30 June 2023

School Infrastructure NSW

Advice regarding PFAS in Groundwater, Rouse Hill High School, 24 Withers Road, Rouse Hill, NSW

Location Plan

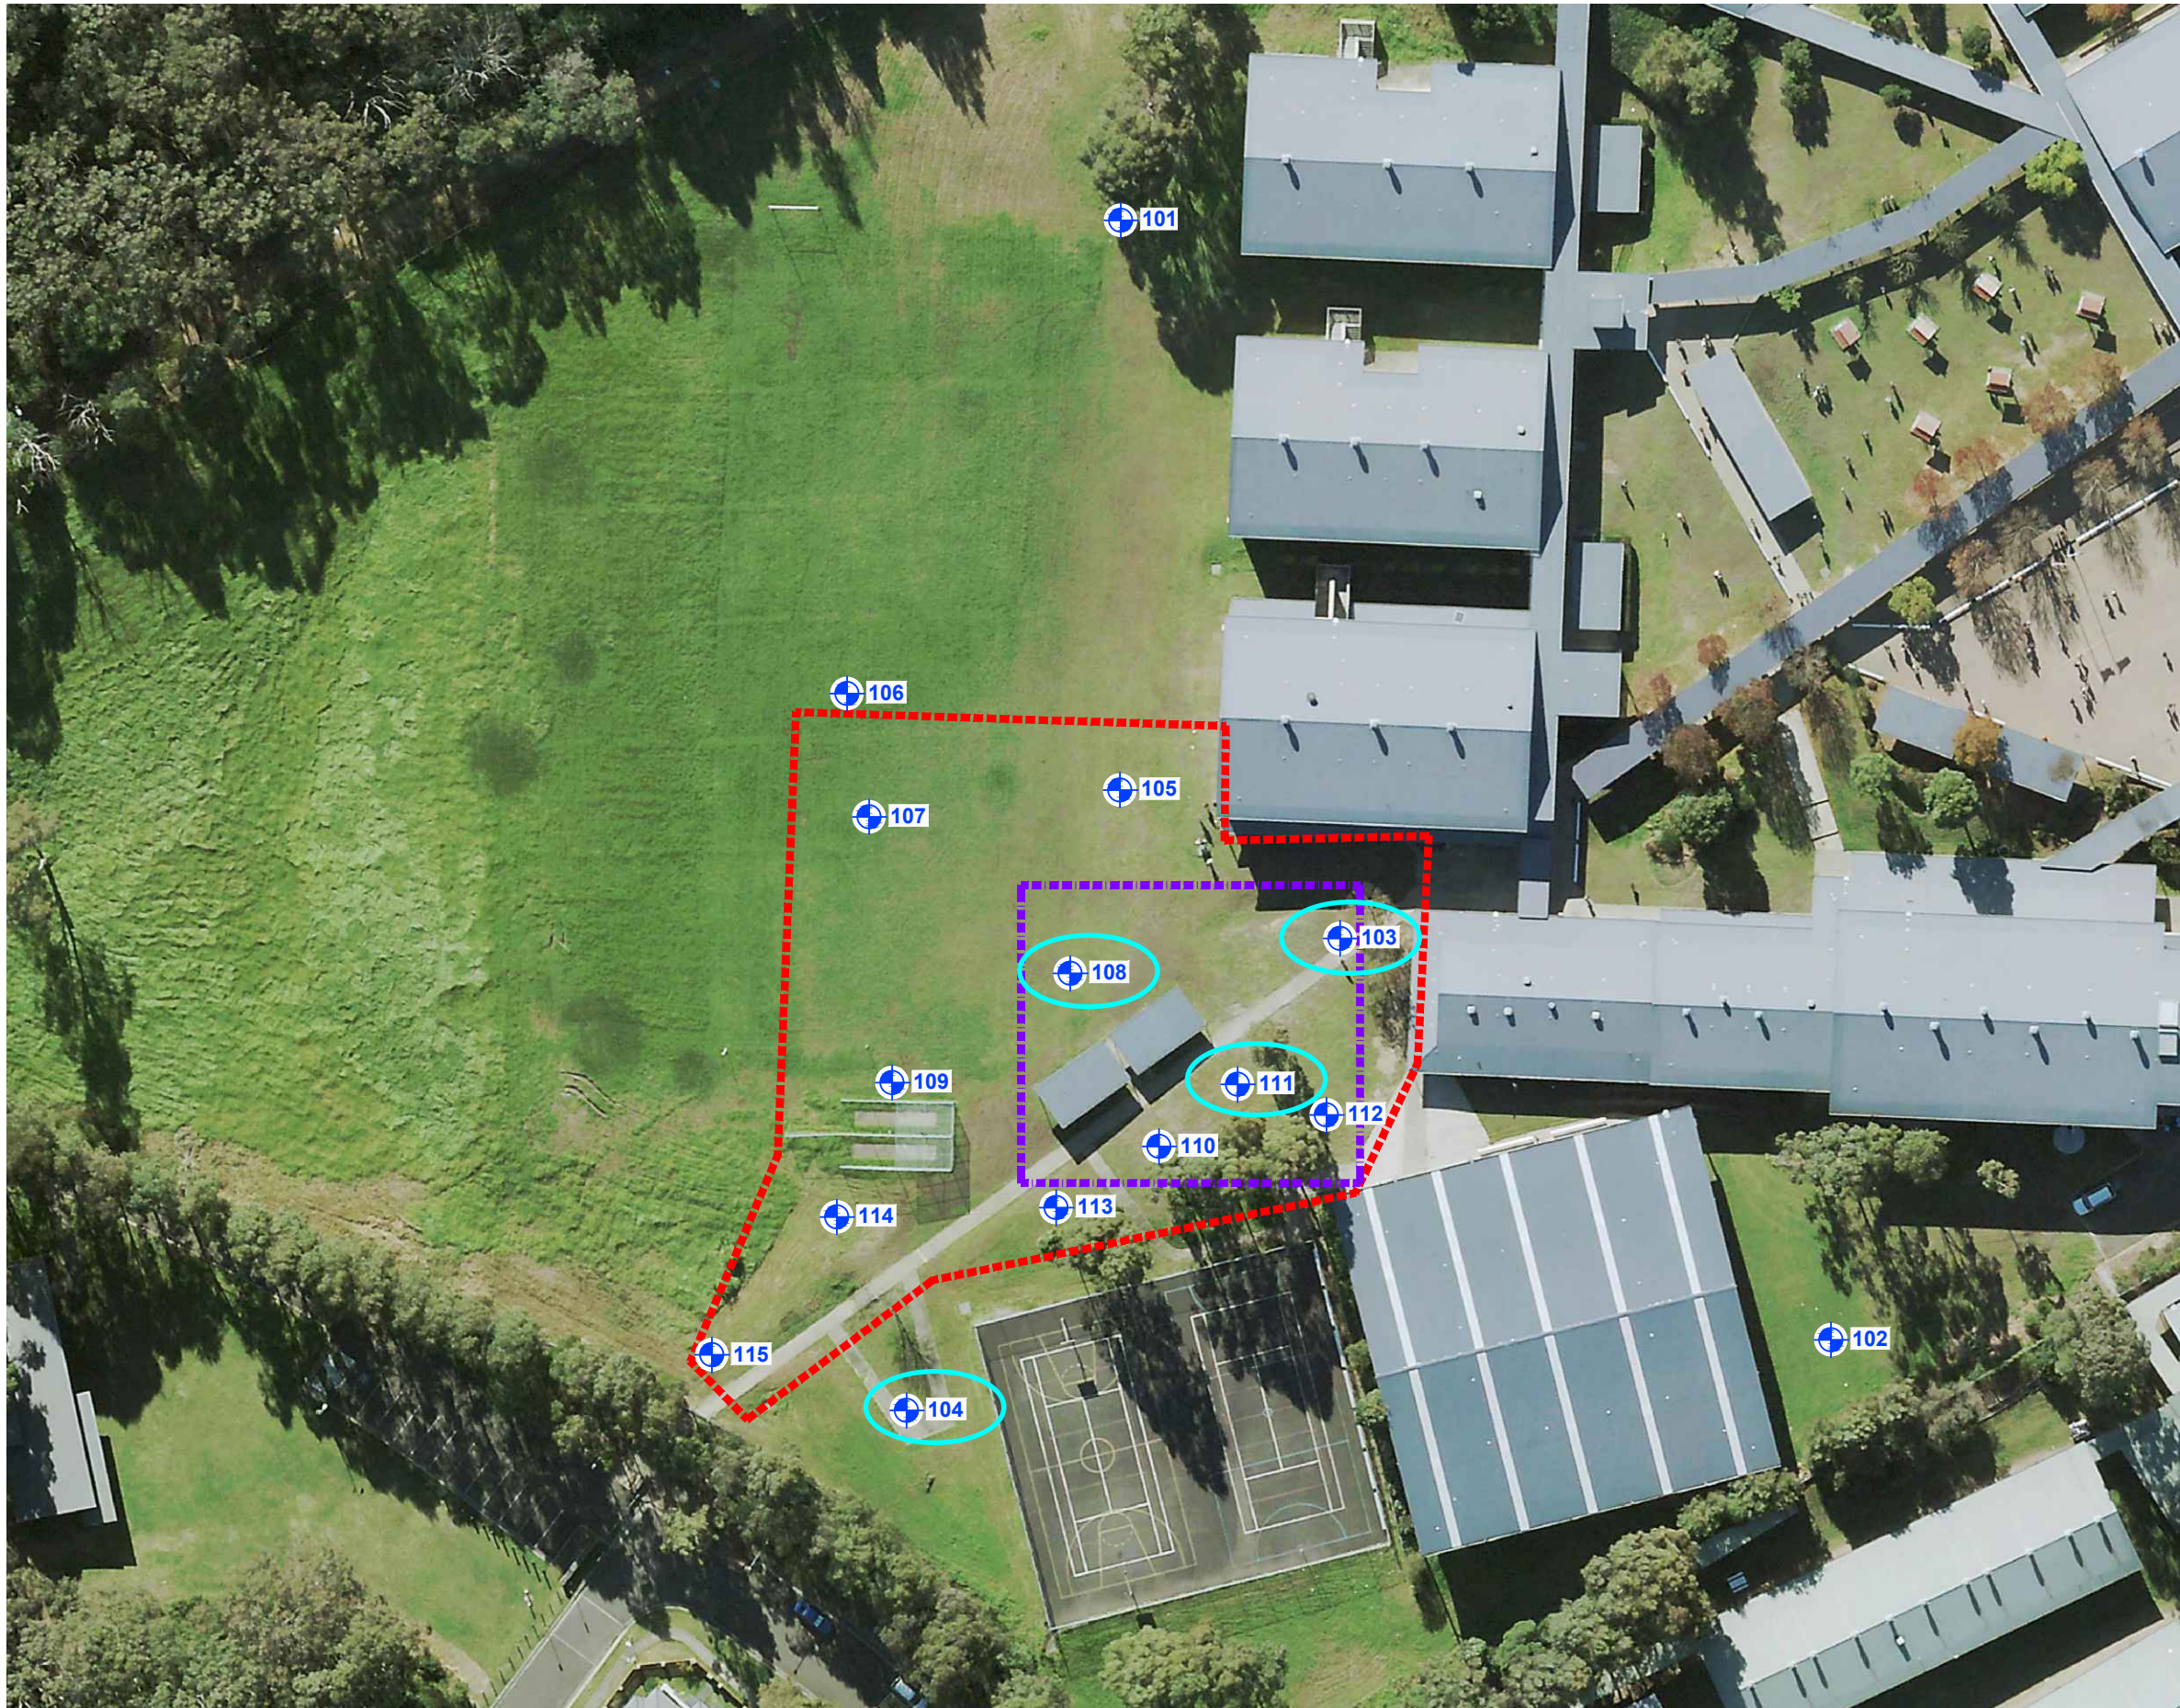
Review of the DSI indicates the highest PFOS concentrations were at monitoring wells BH108 and BH111, with the highest concentration reported at BH111 at 0.005 µg/L. This groundwater monitoring well location is in a hydraulically upgradient area within the developable portion of the RHHS site, and as such, represents groundwater quality migrating onto the site, i.e., it's clearly an offsite/regional issue, rather than a site specific issue. Similar concentrations of PFOS were reported at all groundwater monitoring well locations (irrespective of their location within the RHHS site), with concentrations ranging from 0.001 µg/L to 0.005 µg/L.

DP also reported very low (<1 µg/kg) concentrations of PFAS in soil samples from five boreholes, two of which coincide with monitoring well locations. The soil concentrations were well below adopted HEPA (2020) health or ecological criteria, and at such low concentrations are unlikely to be a source for PFAS in deeper groundwater.

Further assessment of PFAS in groundwater is not warranted.

Subject to the limitations provided in **Attachment 1**, it is considered the reported PFAS levels in groundwater are a regional/offsite issue, and do not pose a risk to human health or offsite ecological receptors. Further assessment with regards to site contamination investigations is not warranted.
